PD 1438

**Re: Waterway Business-Residential Planned Development No. 1438, Parcel B.1
Request for Minor Change**

**Re: PD 1438, Minor Change to Sub-Area Configuration
and Site Plan Approval to Sub-Area B, Parcel B.1**

**Re: Request for Minor Change & Site Plan Approval for Waterway
Business-Residential Planned Development No. 1438 – Parcel C.1**

PARCEL B.1 | NATURALIZED EDGES & FLOATING WETLANDS

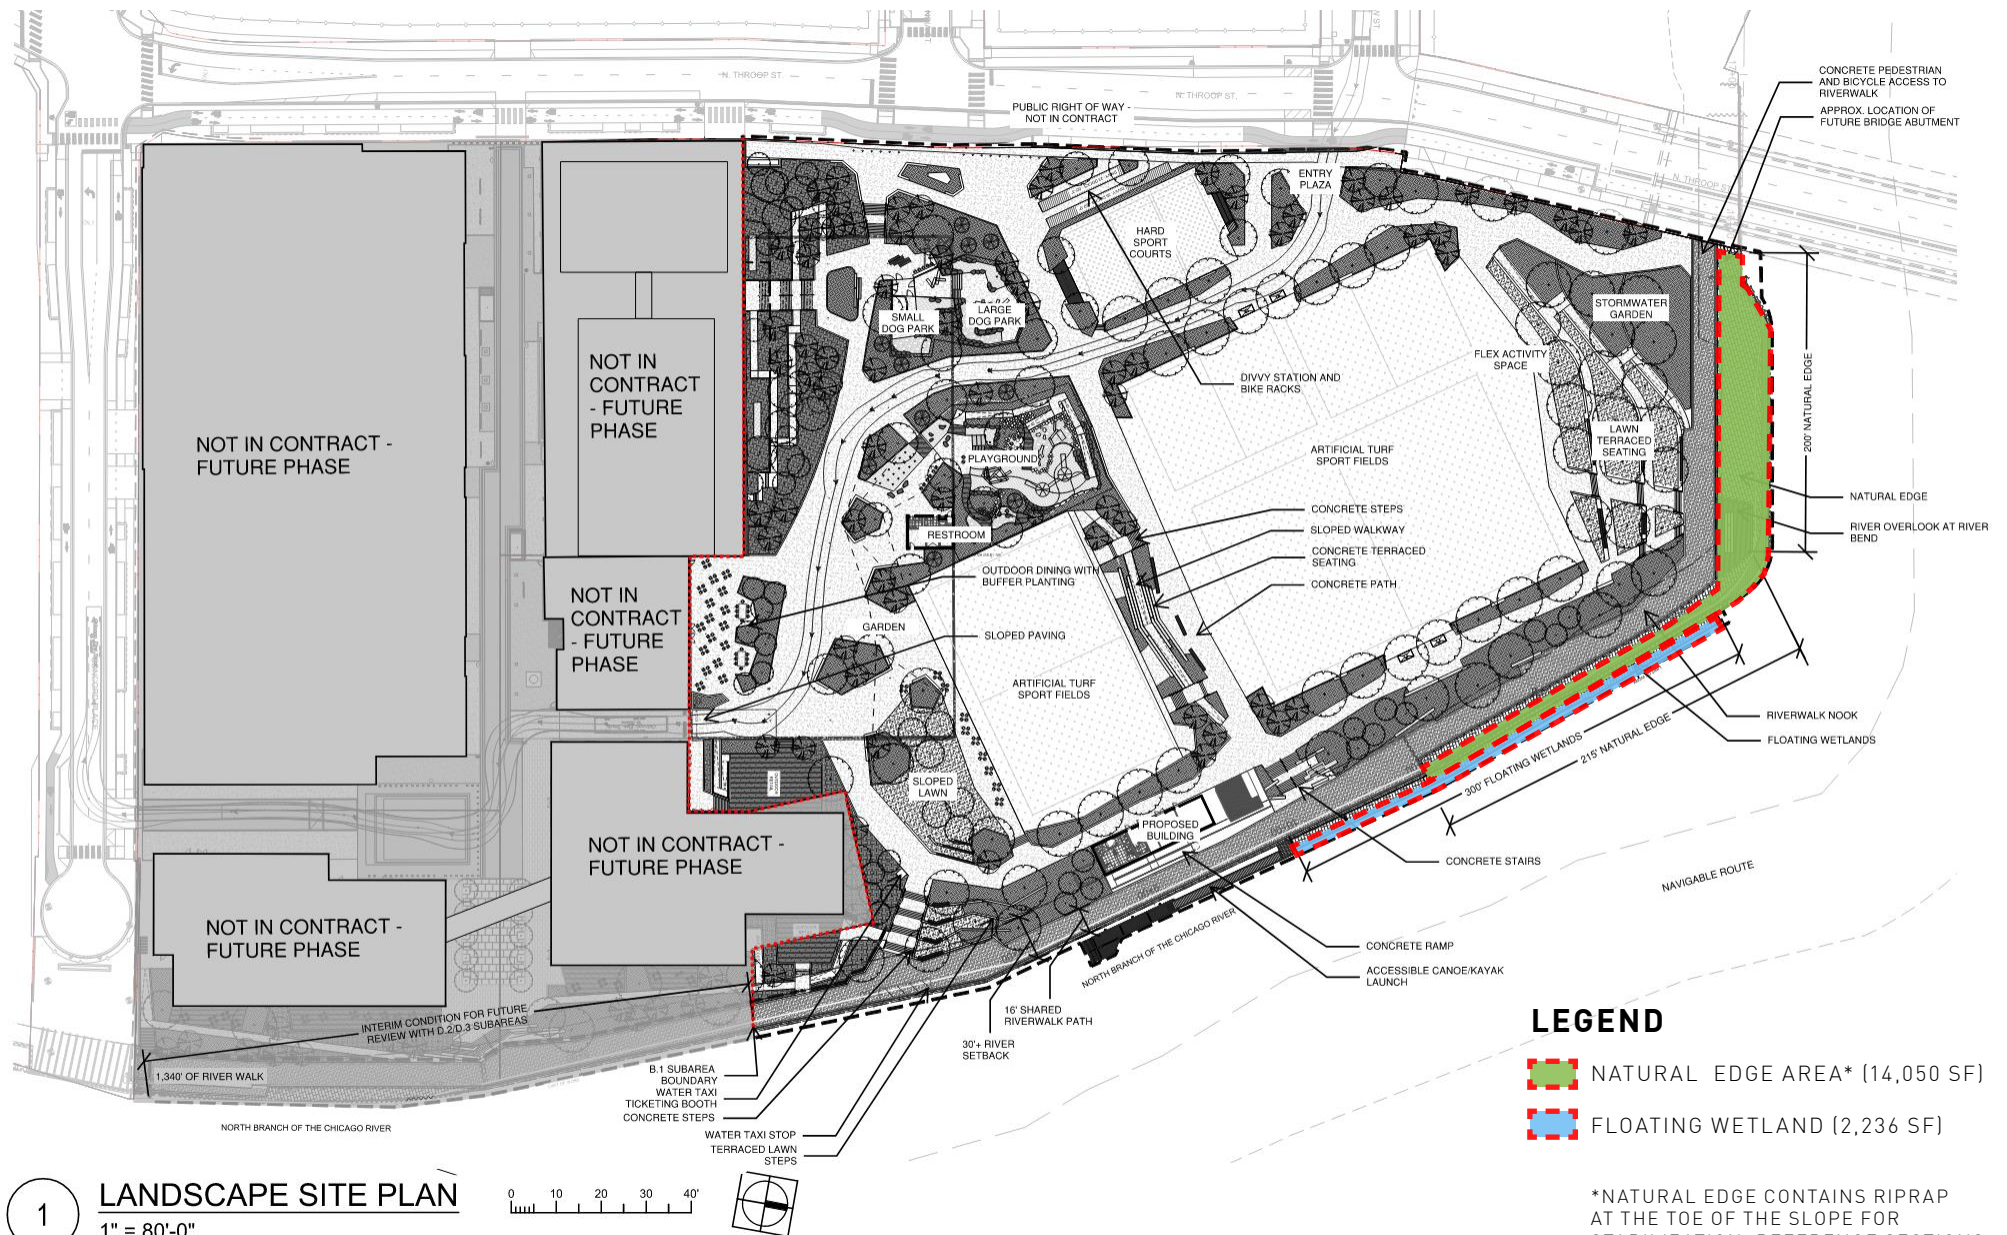
- The overlook has been relocated closer to the river bend and has been reduced in scale.
- Floating wetlands have been relocated to the north of the proposed kayak launch and ramp.

PARCEL B.1 | D1 BUILDING TERRACE SECTION

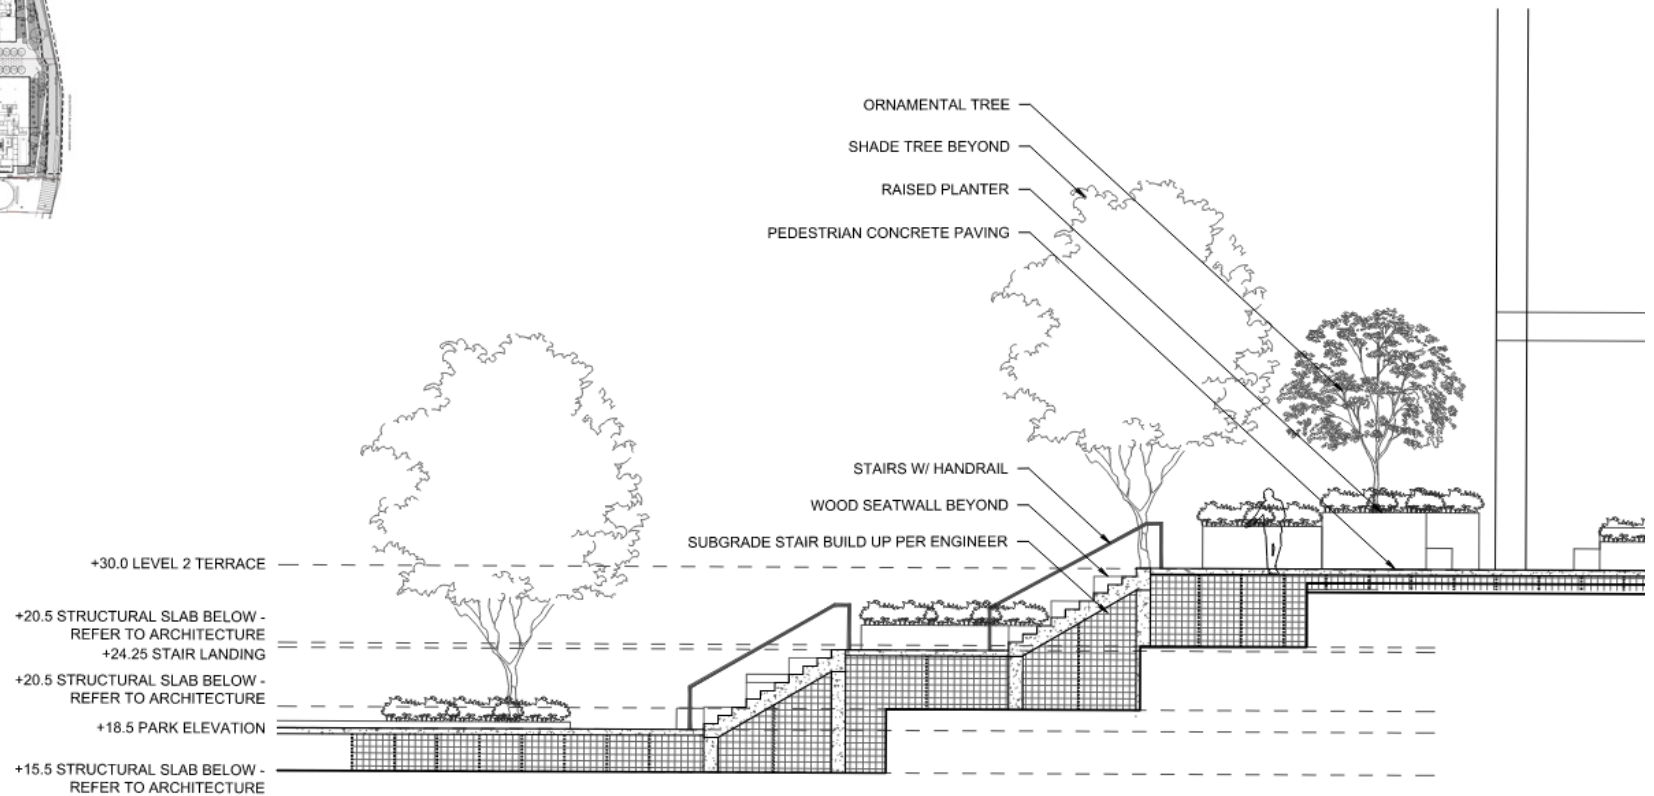
- The stair and ramp access for the D.1 residential building to the park has been improved and better integrated. This revised design allows for inclusive access and better places of respite overlooking the park and aims to increase visibility of the park entrance from primary approaches.

PARCEL B.1 | ARCHITECTURAL SITE PLAN

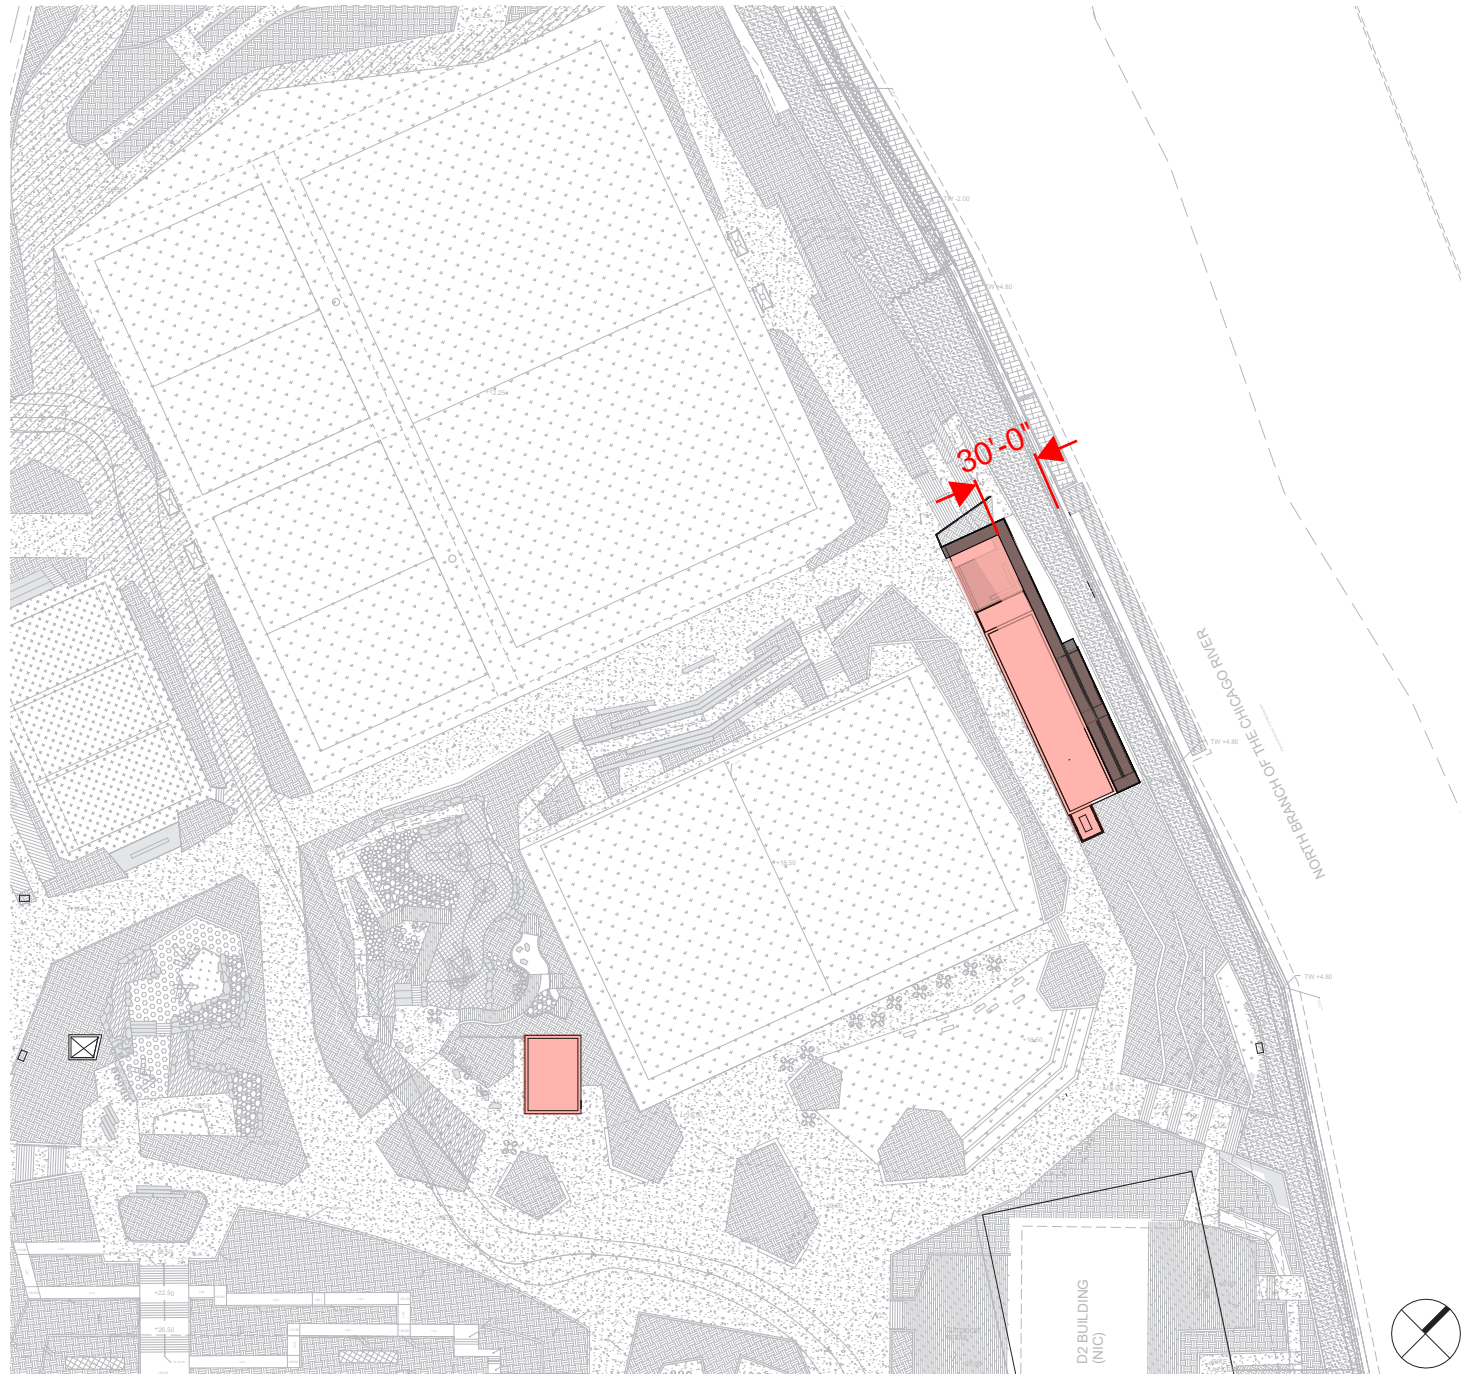
- DIVVY bike station has been added to the plans near the Wabansia Street entry plaza and hard sport courts.
- Access to the river at the concession building has been adjusted to include a switchback ramp that's integrated into the grade change at the concession building and the stairs. Office, kayak storage, and back of house spaces have been better defined, and park storage opportunities have been added.

PARCEL B.1 | PLANS | KAYAK/CONCESSIONS BUILDING & PARKING RESTROOM

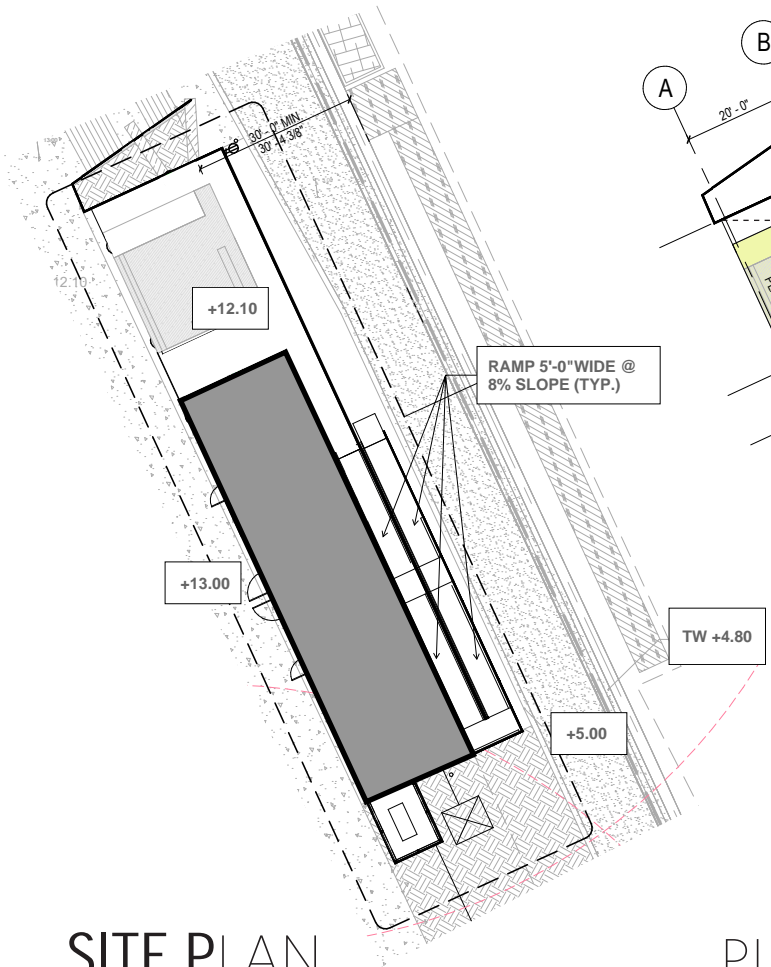
- Louvers have been added to the parking restroom building as required. A parking egress door was relocated from the North Elevation to the West Elevation.

PARCEL B.1 | ELEVATIONS | KAYAK/CONCESSIONS BUILDING

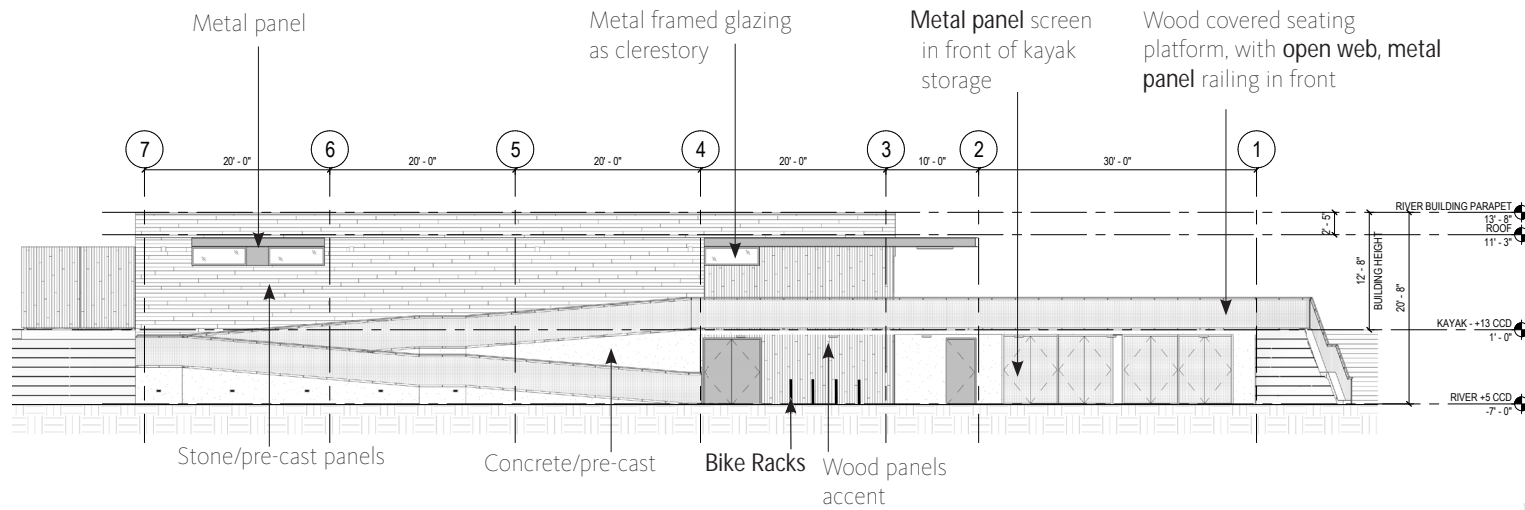
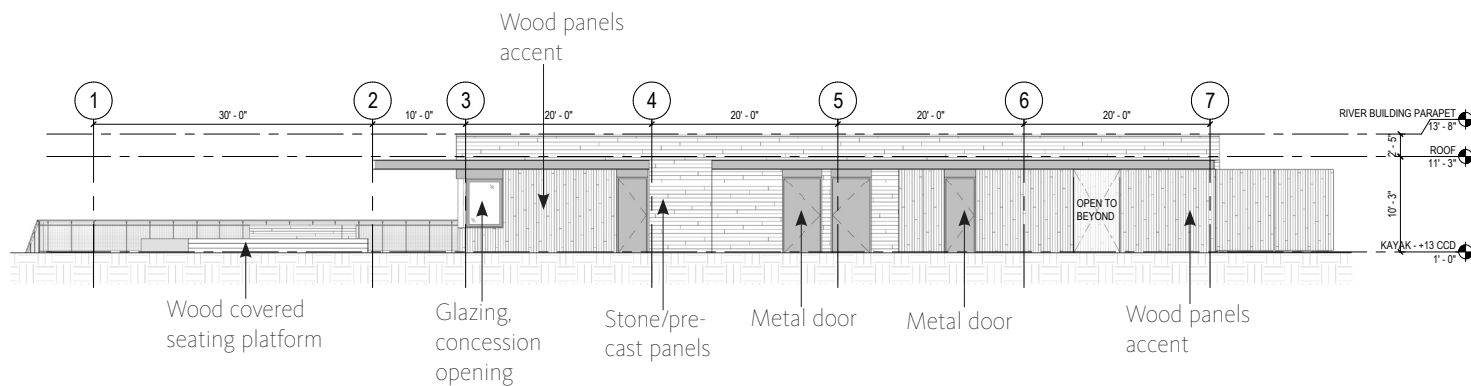
- Concession building windows have been reduced due to MEP functions internal to the building, and a dedicated window has been added for the concession functions specifically. Doors and windows have been developed further based on actual products and materials.
